RE: 2RP-3893

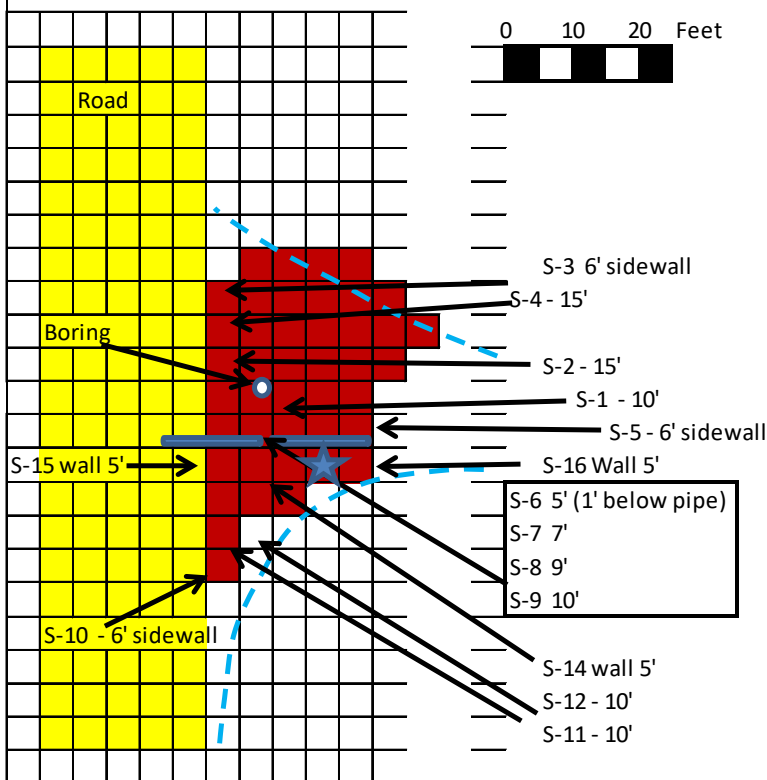
At this time, your proposal, dated January 2, 2017 is **not** approved. OCD requests that a investigation/monitor well be installed as close to the point of release as practicable. Based on your "Figure 1" in the proposal, this will be in the approximate location identified as "S-1 -10' ". Well screenings are to be set at 5ft above water surface and 10 ft below water surface. A survey of the top of the well casing is to be within 1/100 of an inch. OCD also requests that during drilling operations, soil samples be obtained at 5' intervals and tested for BTEX, TPH and Chloride. Once the well is completed, water samples are to be obtained for analyses, utilizing standard, acceptable sampling methods and protocol. Once this data has been obtained, OCD will evaluate, and consider a soil remediation proposal, and if necessary, a water abatement plan. Please advise once the boring activity has been scheduled.

While a well at location S-1 is a reasonable location based upon soil chemistry from the investigation, of concern to us is a location northwest of the pipeline break (identified by samples S6-S9). As best we can tell from this area potentiometric surface map (Plate 2), east-southeast is the direction of groundwater flow in the area of the release. Thus, we believe that the best location would be southeast of the release and at the edge of the footprint identified

by the excavation – a location downgradient from the point of release.

In order to move the well as close as practical to the release point, a location southeast of the pipe break, as shown by the blue star (about 15-foot west of our initial proposed location) in the attached diagram, is a reasonable alternative. Since the pipeline runs east-west, the location shown by the star is as close as practical and lies down gradient from the point of release.

We will expose the pipeline, verify the leak location then move southeast the minimum distance that meets safety setback requirements.
